Model: Model V-C1	Date: 2-Jun-05	No.: RB132001a
-------------------	----------------	----------------

Subject: Service Manual Revision		Prepared by: H.Matsui	
From: 2nd Tech. Support Sec. Service Support Dept			
Classification:	☐ Troubleshooting ☐ Mechanical ☐ Paper path ☐ Other ()	☐ Part information ☐ Electrical ☐ Transmit/receive	☐ Action required ☒ Service manual revision ☐ Retrofit information

The following are changes that were made to the Service Manual before the start of mass-production.

SECTION 3.9.9 PRESSURE ROLLER CLEANING FELT PADS

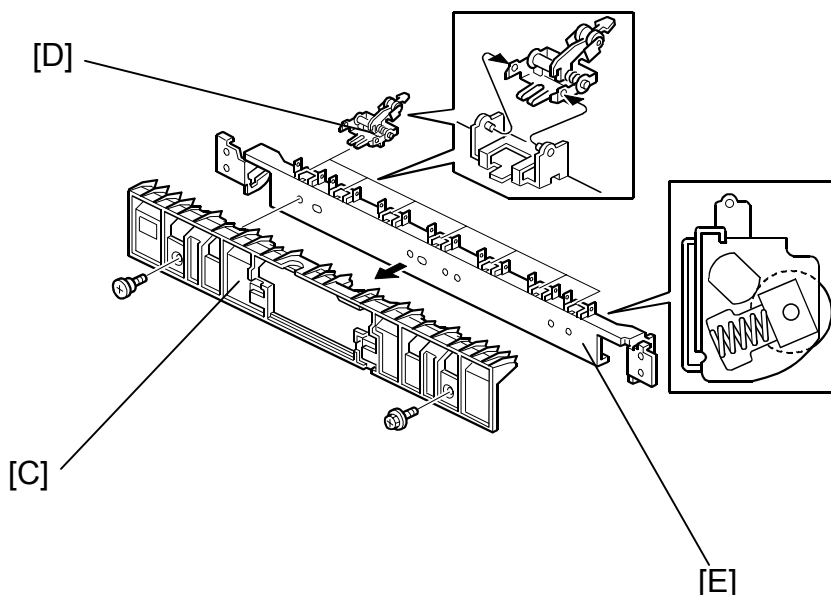
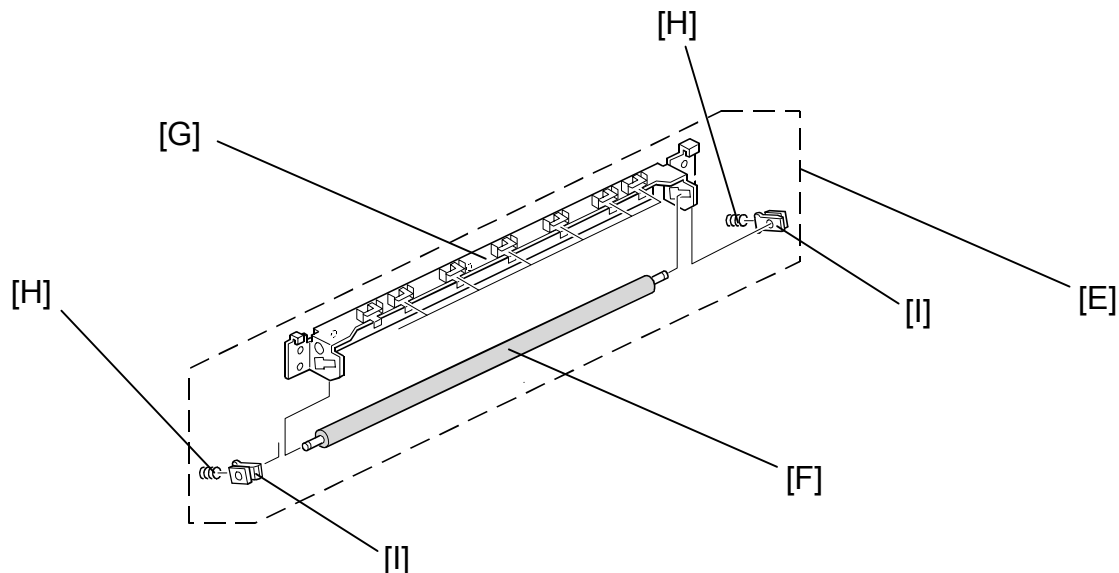
- **Change** the section name to "PRESSURE ROLLER CLEANING FELT ROLLER".
- **Replace** the illustration (B132R406A.wmf) with the following:

- *Add the illustration with the following.*

- **Replace** the illustration explanation with the following:
- **Add the explanation [F] thru [I]**

- [A]: Exit sensor bracket (2 screws, 2 connectors)
- [B]: Lower exit guide assembly (2 screws)
- [C]: Lower exit guide (2 screws)
- [D]: Separation pawl Assy x 7
- [E]: Cleaning felt roller Assy
- [F]: **Cleaning felt roller**
- [G]: **Bracket**
- [H]: **Springs**
- [I]: **Bushing**

SECTION 6.14 FUSING, PAPER EXIT

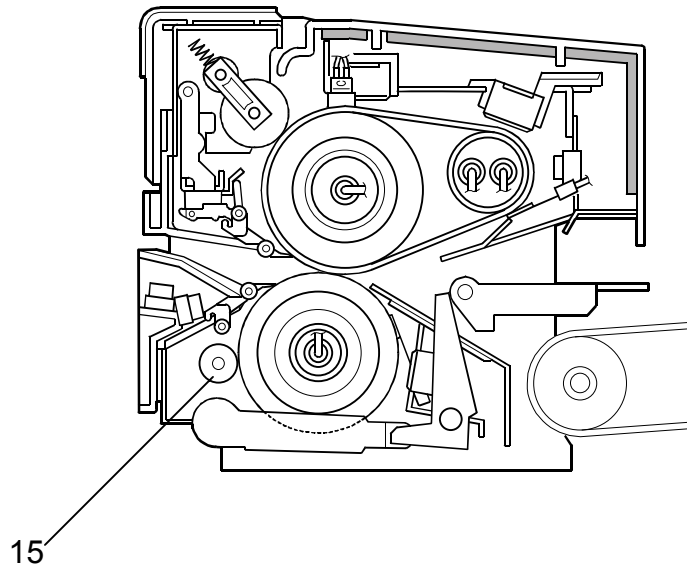
- Replace the illustration with the following:

- Delete “Cleaning Felt – Large” from the list and the illustration (#12).
- Change the name of callout #15 to “Cleaning Felt Roller.”

SECTION 6.15.2 LUBRICATION AND CLEANING

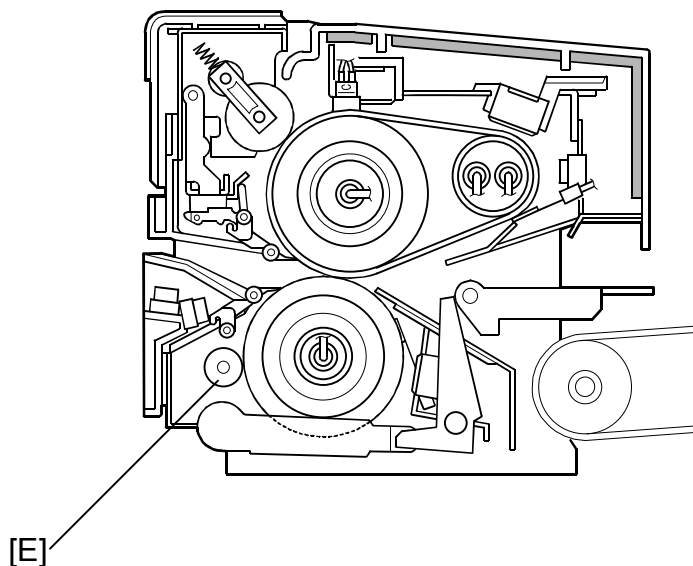
- Replace the illustration with the following:

- Delete “Cleaning Felt – Large” from the list and the illustration ([F]).
- Change the name of callout [E] to “Cleaning Felt Roller.”
- Change the explanation for callouts [E] and [G] as follows:
 - OLD: Felt pads [E], [F] clean the surface of the pressure roller [G].
 - **NEW:** The cleaning felt roller [E] cleans the surface of the pressure roller [G].

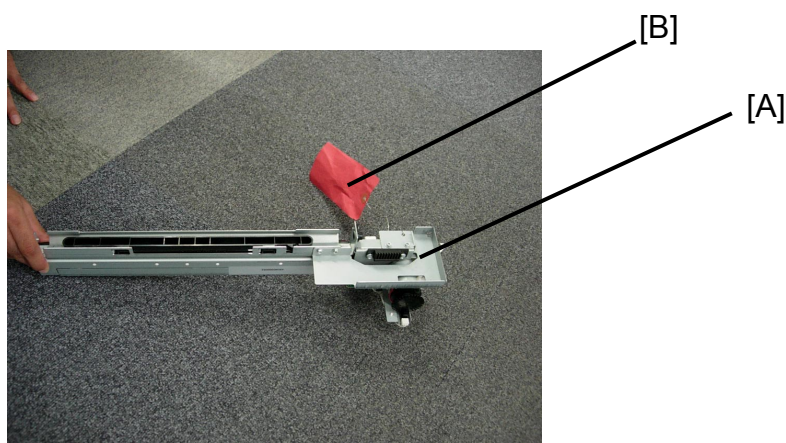
- **Add** the following photograph

Note: The transportation retainer bracket [A] and its shipping tag [B] were added.

1.10.2 INSTALLATION

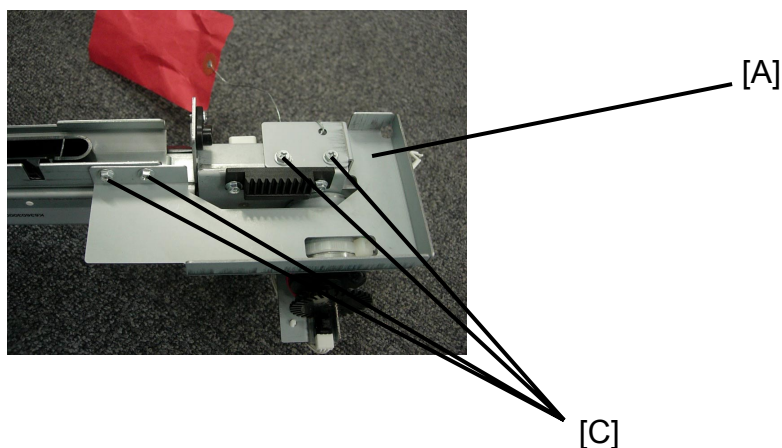
- Add the sentence in **bold** below to Step 4.

4. **Remove the shipping retainer bracket [A] (screws [C]).** Move the punch unit along its rails into the finisher. Make sure that the pin engages correctly at the front and rear.

Parts Addition Information

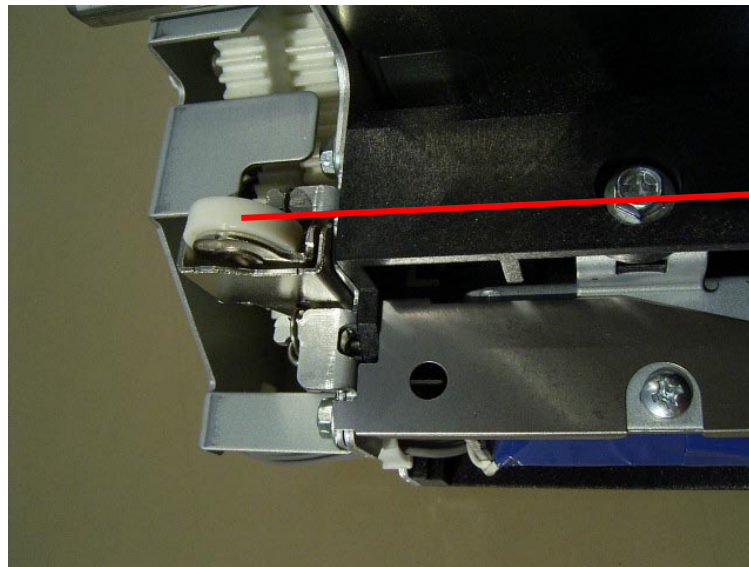
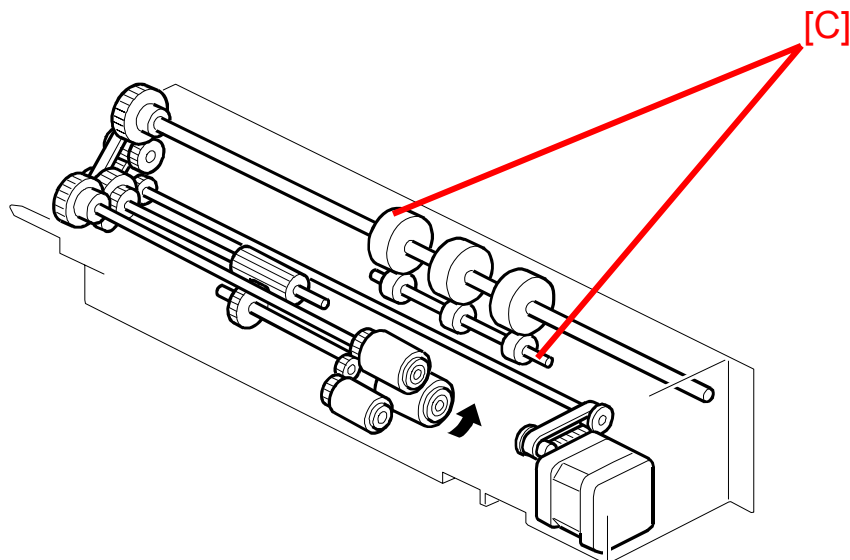
A Tandem Tray Interlock Guide [A] was added to V-C1 machines from August 2006 production (cut-in serial numbers are listed in last page).

To eliminate the gap between the pair of grip rollers [C]. This improves the paper feed performance from the tandem tray.

- The interlock guide presses the part [B] of paper feed unit. When the part [B] is pressed, the pair of grip rollers [C] contacts more firmly through the mechanism in paper feed unit.
- A Tandem Tray Interlock Guide [A] has been already listed in the original Parts Catalog (B0656672, #19 on pg. 62), but this **was** a Parts Catalog mistake. However, this new part is used on actual machines that are assembled from August 2006. Therefore, you do not have to correct the parts catalog.

1.6 KEY CARD BRACKET (B498), KEY COUNTER BRACKET (B452)

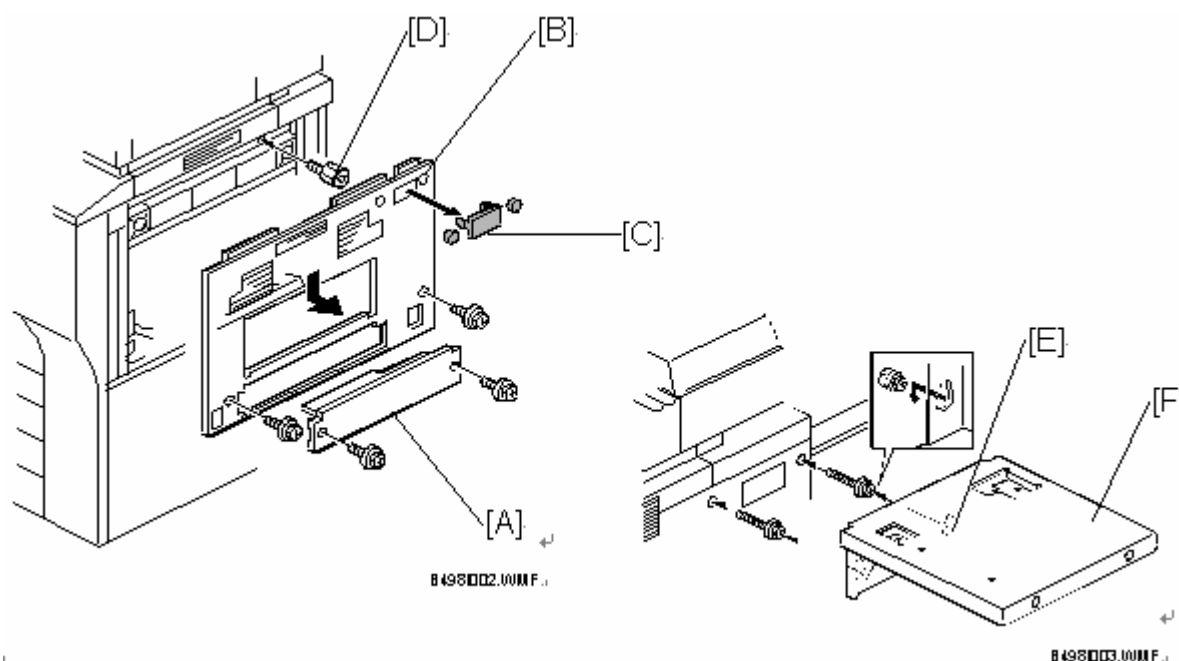
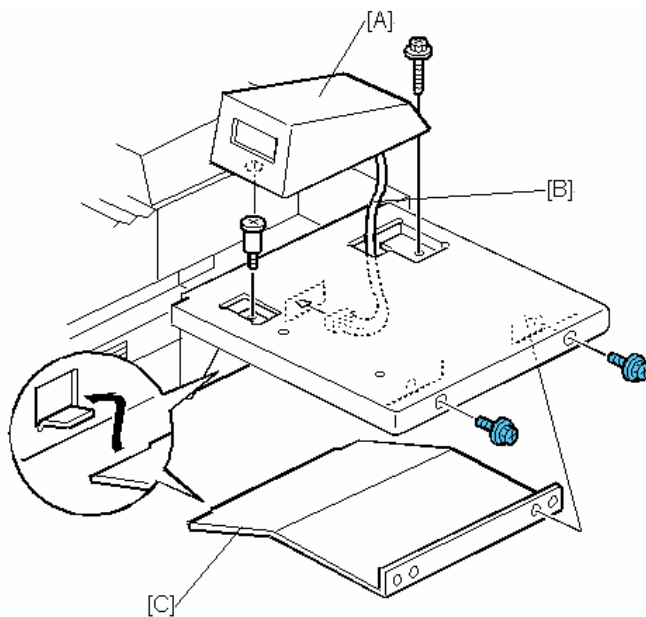
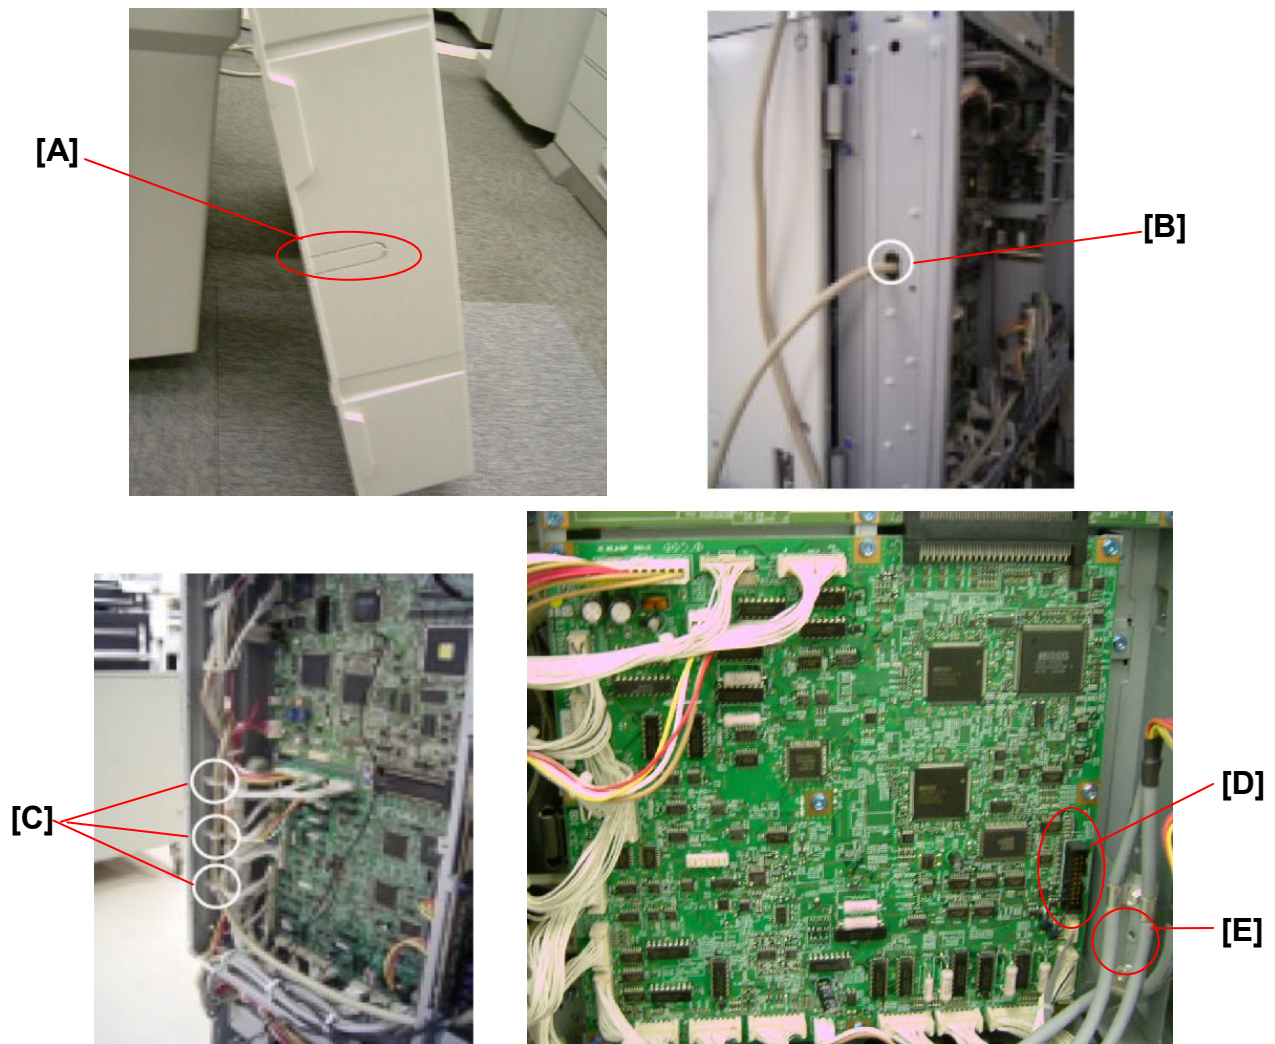
- **Replace** the Installation Procedure for the Key Card.
Note: Steps 9-15 (sentences about the 20-pin Key Counter) were added.

8. Attach the key counter bracket [A] or the Key Card (⚙ x 2).
9. If you are installing the key counter bracket:
 Connect one end of the harness [B] to the key counter bracket [A] (⚙ x 1), and the other end to the 4-pin connector on the right side of the copier. Then attach the bracket support [C] to the side of the copier (⚙ x 2).

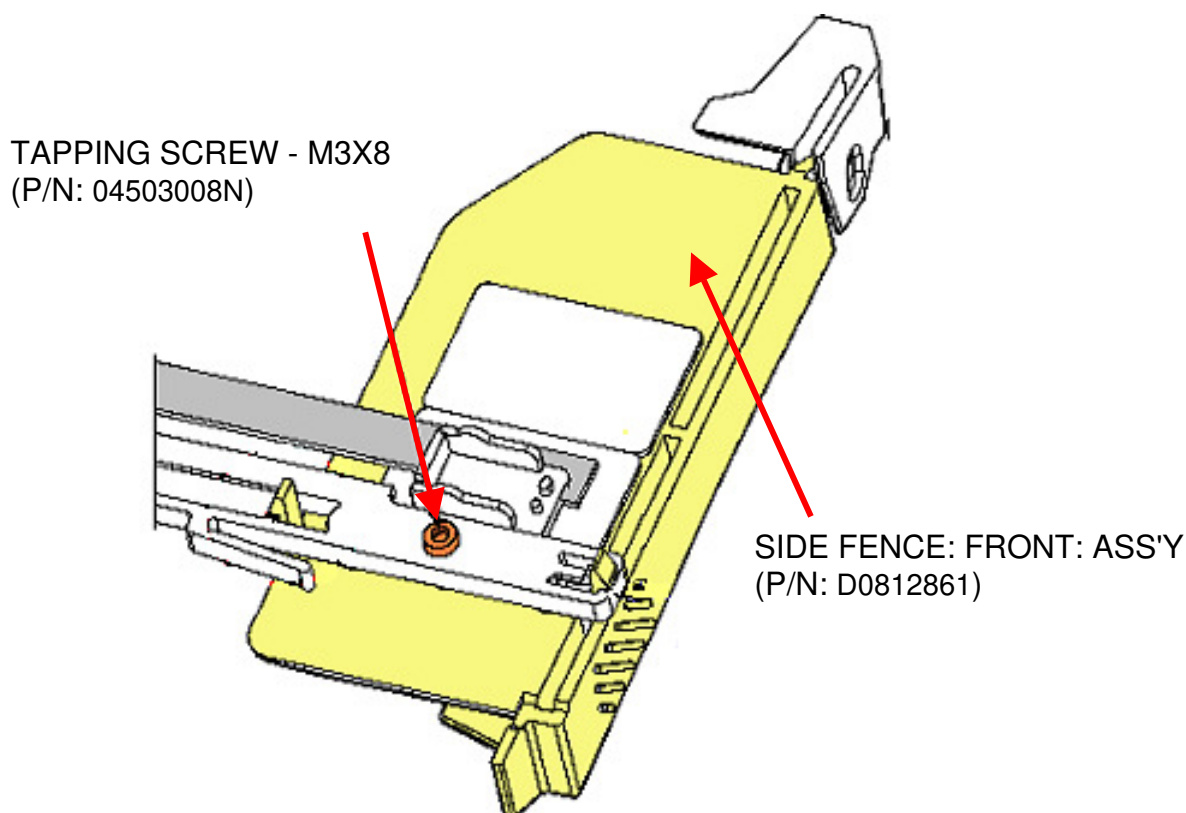
Change: A tapping screw (M3x8) was added to the side fence front assembly.

Reason: To fix the assembly in place, so that it does not detach from the hook when it is slid.
